Re: **Glen Burnie Heights  
Block PP, Lots 40-43  
Variance Application**

SHEET 1 OF 1  
**VARIANCE PLAN**

**GLEN BURNIE HEIGHTS**  
**Section PP, Lots 40-43**

## CONFIRMATION OF PRE-FILE MEETING

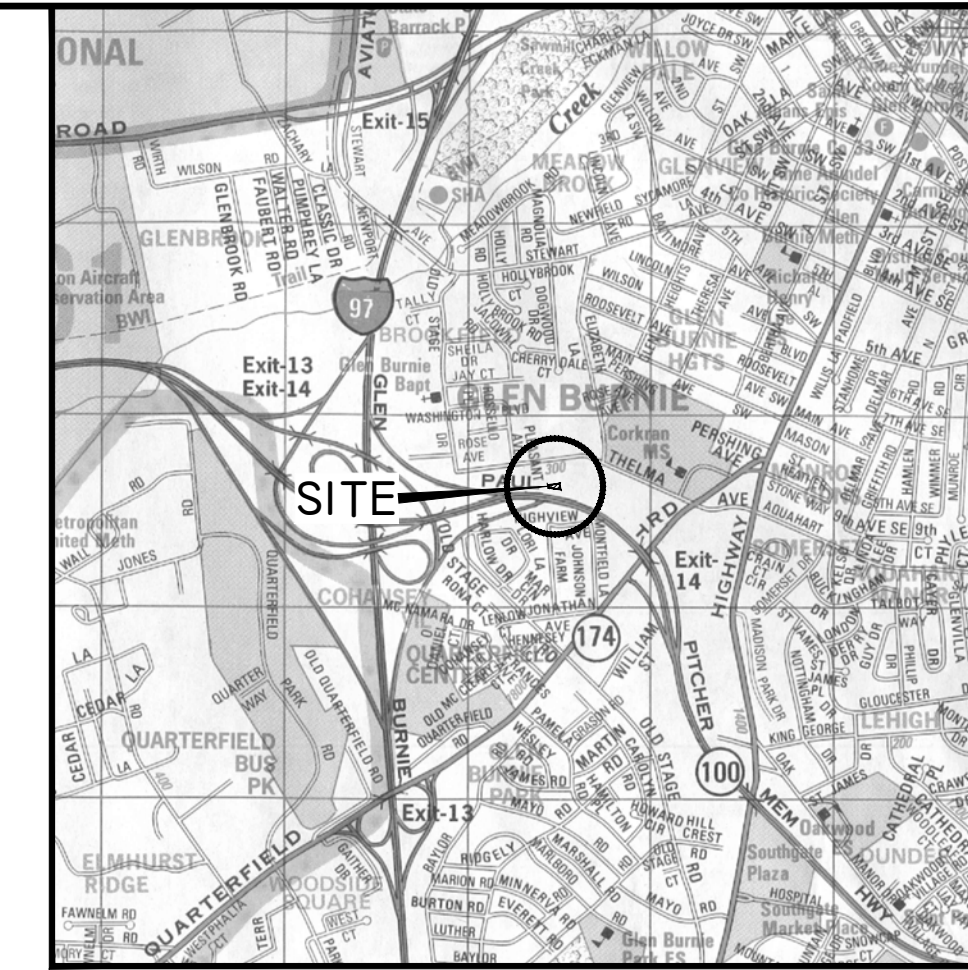
1. This reviewer is not clear about what type of SWM practice (s) are proposed. Per 6.1.4 (G) of the County Stormwater Practices and Procedures manual, SWM facilities shall not be located in areas that are off-limits to development, e.g., natural resources including steep slopes and buffers.

2. Identify site outfall to review the site plan and provide feedback regarding potential impact.
3. A soil boring is required per practice. The suitability and siting of proposed SWM practices should be reviewed. Soil boring information including verification of the suitability of in-situ soils for infiltration shall be submitted. Describe the site's hydrologic, and topographic characteristics and provide a recommendation on the feasibility of various BMPs.

4. All stormwater conveyance systems shall be designed so that no building or habitable structure, either proposed or existing, is flooded or has water impounded against it during the 100-year storm event.

5. Microscale stormwater facility(ies) design should incorporate safe conveyance for overflow discharges from 2, 10, 100-yr 24-hr storm events; plans should show overland relief paths for these storm events and ensure that no structures, or properties are negatively impacted or have water impounded against during these storm events.

6. The County Stormwater manual requires that Infiltration devices uphill from buildings and structures with basements shall be located a minimum of 20 feet from the structure, or the intersection of the structure foundation footing with the phreatic line from the overflow depth of the device, whichever is greater. Please clarify how this requirement is met.

7. Infiltration/filtration devices, including individual lot devices, shall be located a minimum of 10 feet horizontally from any public sanitary sewer or house connection, or property line.

8. The site to ensure that any existing downstream flooding including nuisance flooding issues will be exacerbated by the proposed development.
9. Design professionals should review site runoff and potential (negative, adverse) impacts to neighboring properties, due to changed grades/elevation on a proposed project.
